Tenant Finish for Brighton Recovery Campus

- JANUARY 3, 2017 SECOND SUBMITTAL FOR EACH SEPERATE BUILDING PARCEL
- JANUARY 6, 2017
- JANUARY 17, 2017
- JANUARY 24, 2017
- MARCH 20, 2017

EXISTING SITE PLAN

A1 1

EXISTING SITE PLAN

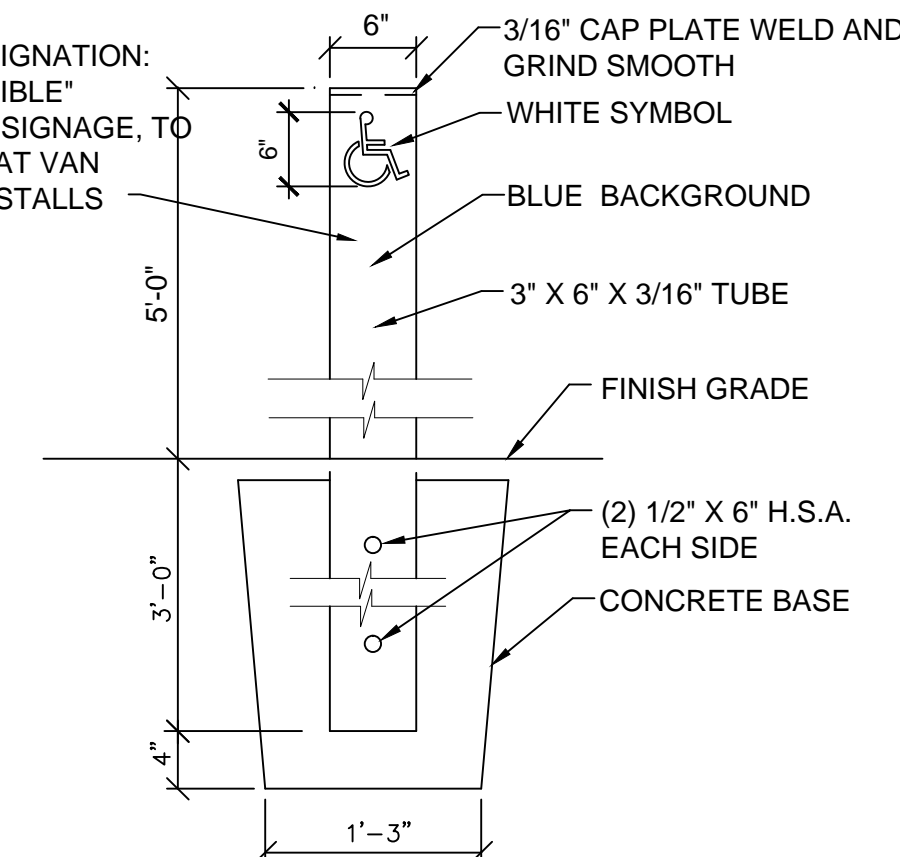
NOTE: ENTIRE EXISTING PARKING AREAS, INCLUDING DRIVEWAYS TO RECEIVE NEW ASPHALT OVERLAY AND NEW PARKING STALL STRIPING, AS PART OF ADDENDUM #4 -SEE NEW SPECIFICATION SECTION ON SHEET A1.2.

NEW ONE HOUR FIRE RATED WALL ASSEMBLY TO BE PROVIDED ABOVE NEW CEILING, ABOVE EXISTING EXTERIOR WALL STRUCTURE, WITHIN THE ROOF STRUCTURE OF EACH EXISTING BUILDING. THIS WILL OCCUR WHERE EXISTING ROOF OVERHANGS ARE ADJACENT TO OTHER EXISTING BUILDING ROOF OVERHANGS, AND WHERE EXISTING BREEZEWAY ROOFS OCCUR. WALL ASSEMBLY TO EXTEND FROM BOTTOM OF EXISTING ROOF OVERHANG TO BOTTOM OF EXISTING ROOF SHEATHING. UL DESIGN U305, OR U314: 5/8" SHEETROCK FIRECODE CORE PANELS, OR 5/8" SHEETROCK ULTRALITE PANELS FIRECODE X, OR 5/8" FIREROCK PANELS ON 2X4 WOOD STUDS @ 16" OR 24" O.C. (ONE HOUR FIRE RATED CONSTRUCTION). THIS ALLOWS A FIRE RATED SEPERATION BETWEEN EXISTING BUILDING EXTERIOR WALLS AND CANOPIES/ BREEZEWAY ROOF STRUCTURES. THIS FIRE RATED WALL ASSEMBLY WILL EXTEND FROM THE TOP OF THE ROOF BEARING WALL STRUCTURE, TO THE BOTTOM OF THE EXISTING ROOF SHEATHING.

ALSO PROVIDE NEW FIRE SPRINKLING SYSTEM AT ALL EXISTING BUILDING EXTERIOR ROOF OVERHANG SOFFITS AND BREEZEWAY SOFFITS. FIRE SPRINKLING SYSTEM TO BE NFPA 13 SYSTEM, AND TO MEET ALL LOCAL JURISDICTION AND NATIONAL REQUIREMENTS. REFER TO SHEET P02 FOR FIRE SPRINKLING SYSTEM REQUIREMENTS. SYSTEM TO BE DESIGNED FOR EXTERIOR APPLICATION

NOTE: THE REQUIRED SLOPE AT ALL NEW A.D.A. PARKING STALLS AND ACCESSIBLES IS 1:48 PER ICC A117.1-09, SECTION 502.5, AFTER RECEIVING NEW ASPHALT OVERLAY

NOTE: CONTRACTOR TO VERIFY CONDITION OF EXISTING SIDEWALKS AT A.D.A. ACCESSIBLE AISLE ROUTES AND REPAIR OR REPLACE ALL SECTIONS OF EXISTING SIDEWALKS TO MEET THE REQUIREMENTS OF ICC A117.1-09, CHAPTER 4, REGARDING SLOPE (NOT GREATER THAN 1:20), CROSS SLOPE, CHANGES IN LEVEL, CLEAR WIDTH, PASSING SPACE, ETC.
